## Central Valley Regional Water Quality Control Board

**ORDER AMENDING NOTICE OF APPLICABILITY: STATE WATER RESOURCES CONTROL BOARD CLEAN WATER SECTION 401 GENERAL WATER QUALITY CERTIFICATION FOR REGIONAL GENERAL PERMIT 8 (ORDER WQ 2023-0061-DWQ), UNION PACIFIC RAILROAD COMPANY, CANYON SUB DERAILMENT PROJECT, PLUMAS COUNTY, WDID NO. 5A32CR00241A2**

**AMENDMENT:**

Figure 2. Staging and Project Impacts Location Map

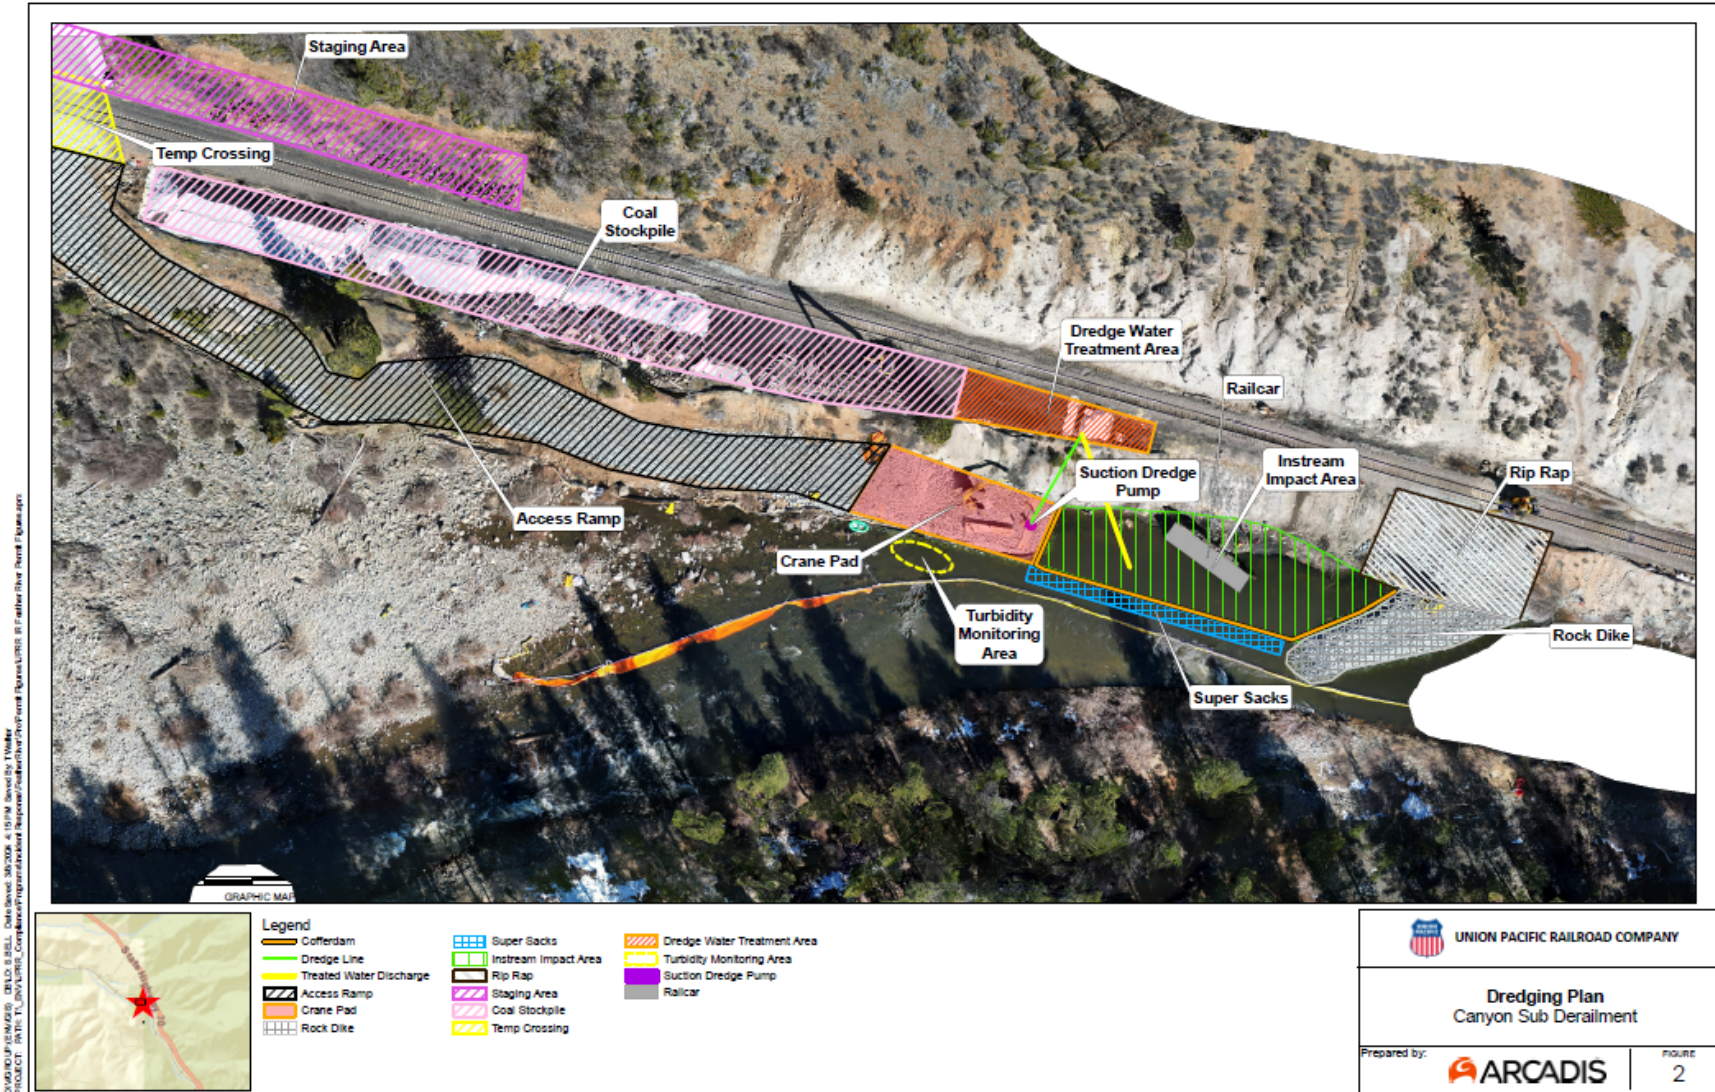
Union Pacific Railroad (UPRR) is requesting an amendment to the Notice of Applicability to authorize restoration and bank stabilization activities on the hillslope and north riverbank of the Middle Fork of the Feather River where the derailment occurred and at the access ramp and crane pad northwest of the derailment location. Therefore, Section I; Section II; and Section III are amended in underline format below. Section II, Table 2, Section IV, Table 5, and Attachment A, Figure 3 were added.

- A combination of bio-engineered and rip rap hardening will be implemented to restore and stabilize the embankment below the UPRR right-of-way, the north streambank where the derailment occurred, and the access ramp and crane pad to the northwest of the derailment location as per UPRR's *Restoration and Stabilization Plan* dated 10 April 2024, enclosed and incorporated herein by reference.
